30 June 2021

2200600

**RE: RESPONSE TO REQUEST FOR INFORMATION – DA2020/256
2-6 PILGRIM AVENUE & 11-13 ALBERT ROAD, STRATHFIELD**

Figure 1 Comparison of original and amended proposals (Pilgrim Avenue elevation)

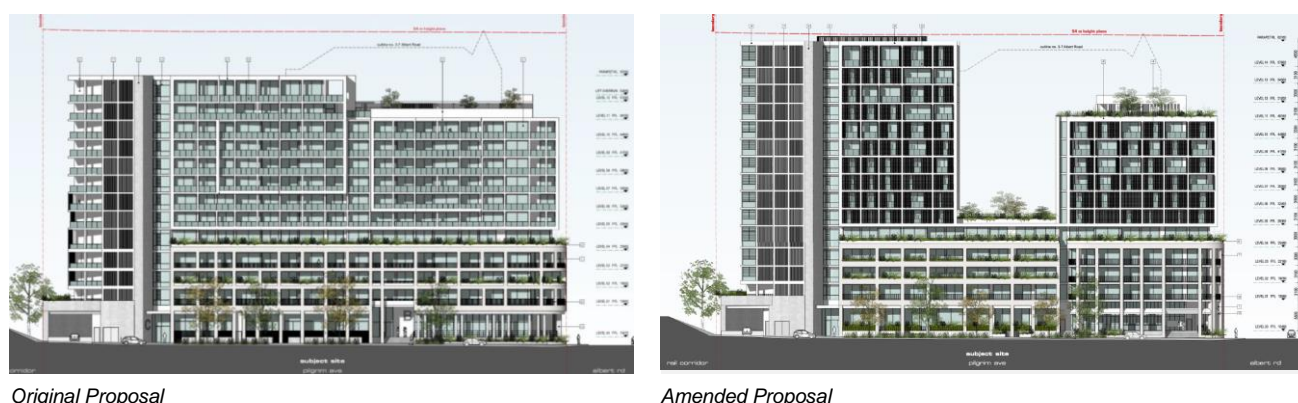
- Deletion of Building B and subsequent creation of two towers, Building A at the south of the site with 11 storeys and Building P (formerly known as Building C) at the north of the site with 15 storeys, above a four-storey podium.
- Increase of Building P height by two storeys (from 13 to 15 storeys) to accommodate a redistribution of floorspace from the removal of Building B.
- Internal re-planning of apartment layouts in both buildings.
- Setting back Building P 800mm from the northern boundary with the rail corridor to allow for building maintenance.
- Revising setbacks at the interface with the adjoining site at the north-eastern corner to enable future development on the adjoining site.

Photomontages of the original and amended proposal are provided for comparison in **Figure 1** below.

Figure 2 'U' shaped building 'indents' to be considered under Part 3F

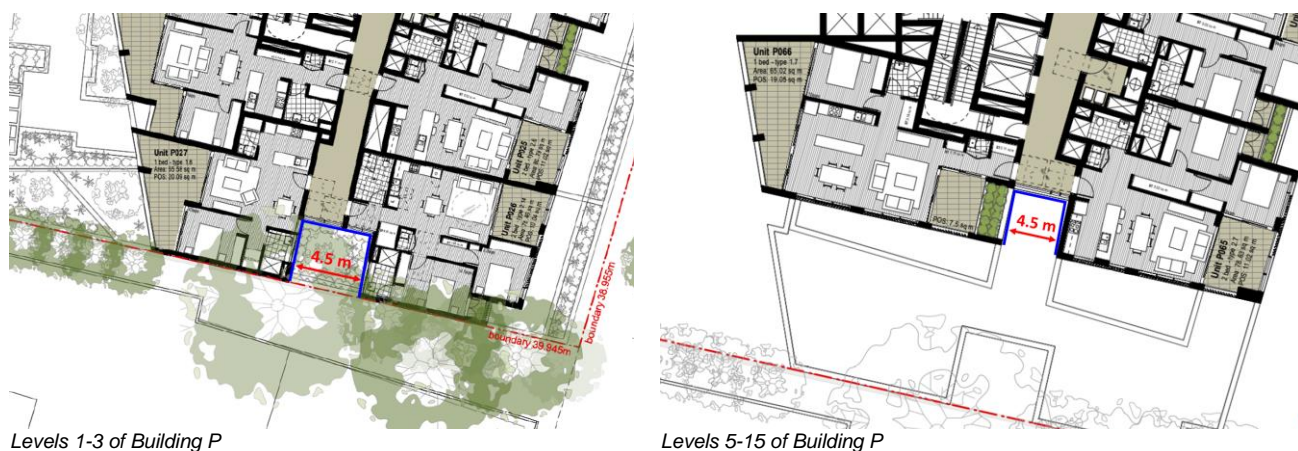
In addition, Kennedy Associates have identified two further 'non-compliances' relating to the arrangement of openings around the 'U' shaped building 'indents' on the eastern facade of Building P. These indents are located at the end of the east / west running corridor of Building P and are approximately 4.5m wide x 4.5m wide and open on the eastern edge. These indents on Levels 1-3 and Levels 5-15 are shown in **Figure 2** below. The three walls surrounding the indent contain openings to two units as well as a glazed end to the building's circulation space. Whilst the provisions of Part 3F may not technically apply to the proposed openings (the separation is not between different buildings, or to a boundary), in Kennedy Associate's opinion, the achievement of reasonable levels of privacy between the units arranged around this relatively 'compact' space should be considered.

On Levels 1-3, the arrangements of the two bathroom windows facing each other have been located offset from one another, have a high sill level and are to be fitted with translucent glass. This arrangement ensures that:

- there are no direct overlooking opportunities between the two bathroom windows (located on opposing walls); and
- there are no angled view opportunities between the two bathrooms windows and other openings in the indent (for example, the glazed corridor end, from upper levels).

On Levels 5-15, the location, size and treatment of the openings has been carefully considered by Kennedy Associates in order to provide appropriate privacy to and from units through the following strategies:

- fixed vertical blades are incorporated to the glazed corridor end, allowing views straight out but restricting angled views to the adjacent balcony;
- a planter is incorporated along the open edge of the balcony, facilitating screen planting; and
- the south facing wall has been left blank, to avoid openings directly opposite each other.
